2011 Change Proposals - New Allowances (4 Items)

These are **PROPOSED** Changes only based on driver and director suggestions. Please comment below. These are proposed NEW allowances to the 944 spec rule set.

2011-4.) Lexan rear Qtr windows

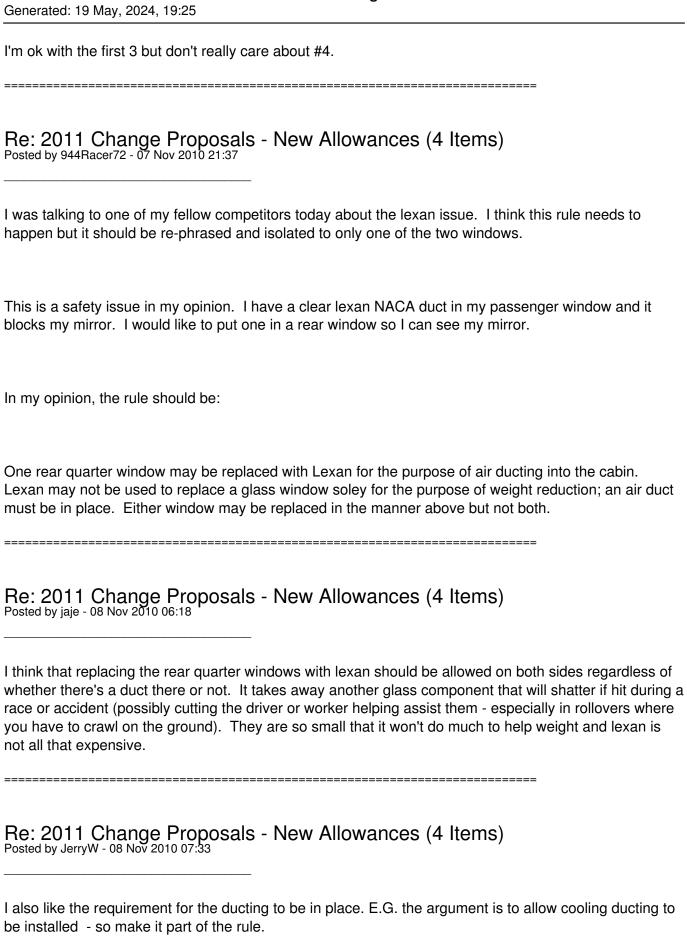
Proposal: Allow rear replacement of glass qtr windows with lexan and to allow air ducting to be installed in these lexan windows. No changes to rear hatch.

Justification: Makes it a nice clean way to provide fresh air ducting.

Given the back hatch is still glass - I don't see swapping the side windows reduces the amount of glass

944-SPEC - 944SPEC - low cost wheel to wheel racing Generated: 19 May, 2024, 19:25 shards in a wreck. I'd support the lexan side window with the above change. Re: 2011 Change Proposals - New Allowances (4 Items) Posted by 944Racer72 - 08 Nov 2010 07:45 jaje wrote: I think that replacing the rear quarter windows with lexan should be allowed on both sides regardless of whether there's a duct there or not. It takes away another glass component that will shatter if hit during a race or accident (possibly cutting the driver or worker helping assist them - especially in rollovers where you have to crawl on the ground). They are so small that it won't do much to help weight and lexan is not all that expensive. Jaje, I think the fear is that opening up the rule means ":everyone HAS to do it": for competetive advantage. If it is only one of the two windows and MUST have a duct, there is no weight advantage. Surely the Lexan+duct+hose weighs about the same as a stock window. Re: 2011 Change Proposals - New Allowances (4 Items) Posted by jaje - 08 Nov 2010 08:03 the rules completely by just allowing those to add lexan to both sides will be cheap and easy to do (a sheet of lexan costs \$30 to do these windows and you can drill and pop rivet it in place in probably 20 mins time). By doing this to both sides it also helps get rid of some potential glass that is closer to the

I understand that it might be similar weight if required to run an actual duct system. However to simplify driver's area (even though the back hatch is glass). I am mainly looking at it from a law perspective where if you make a rule it has to be easy to interpret (and clear as to the spirit it was written in) - getting rid of any grey area makes it so.
